SUBJECT: COMANCHE PEAK NUCLEAR POWER PLANT, UNITS 3 AND 4
DOCKET NUMBERS 52-034 AND 52-035
SUPPLEMENTAL RESPONSE TO REQUEST FOR ADDITIONAL INFORMATION
NO. 5854 (SECTION 11.2)

RAI NO.: 5854 (CP RAI #224)

SRP SECTION: 11.02 - Liquid Waste Management System

QUESTION NO.: 11.02-18

Figure 11.2-201 Liquid Waste Management System Piping and Instrumentation Diagram (Sheet 9 of 10)

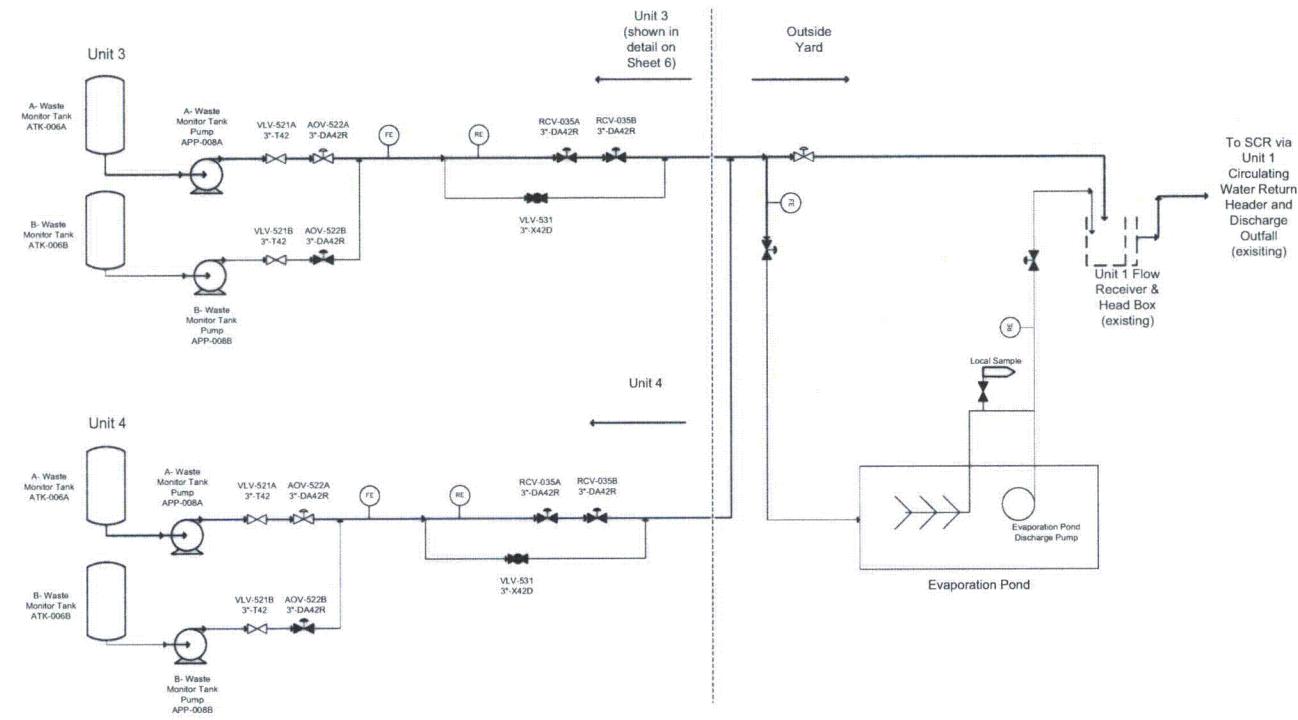
The staff's review of FSAR Section 11.2 and of the applicant's responses to related RAIs on the evaporation pond found that design information on site-specific sample points and locations was not fully described. These site-specific sample points, that ensure that representative samples of the evaporation pond are taken before its contents are transferred to the SCR via the CPNPP Units 1 and 2 circulating water return line, are planned to be located during the "detailed design." In FSAR Section 11.2, please describe the "detailed design" information on the site-specific sample points and locations; discuss the operational program and applicable procedures and NRC guidance; and identify the sample points and locations on a P&ID of the evaporation pond that will satisfy its stated design objective.

The sampling procedures for the evaporation pond are governed by the Offsite Dose Calculation Manual (ODCM), which adopts NEI 07-09A as described in FSAR Subsection 11.5.2.9. NEI 07-09A fully describes elements of the process and effluent monitoring and sampling programs required by 10 CFR 50, Appendix I and 10 CFR 52.79 (a)(16). NEI 07-09A Subsection 6.4.1 states that liquid releases shall be characterized using sampling and analytical procedures to assess the amounts of radioactivity being released to the environment and for determining doses to offsite receptors. Further, NEI 07-09A Section 7 lists the references used in developing the template, including NUREG-1301 and RG. 1.21. Thus, guidance from these two documents is incorporated in NEI 07-09A, as reviewed and approved by the NRC, and is included in the ODCM by adopting NEI 07-09A.

See attached marked-up FSAR Revision 2 pages 2.4-97, 11.2-3, 11.2-4, 11.2-8, 11.2-16, 11.2-17 and Figure 11.2-201, Sheet 9.

The evaporation pond discharge pump also acts as a recirculation pump for the pond. The pond is recirculated sufficiently to obtain a representative sample at the discharge pump before discharging the pond contents to the CPNPP Unit 1 flow receiver and head box. The procedures for recirculation and sampling are governed by the site-wide ODCM, which adopts NEI 07-09A, thus addressing NRC guidance such as NUREG-1301 and RG 1.21.
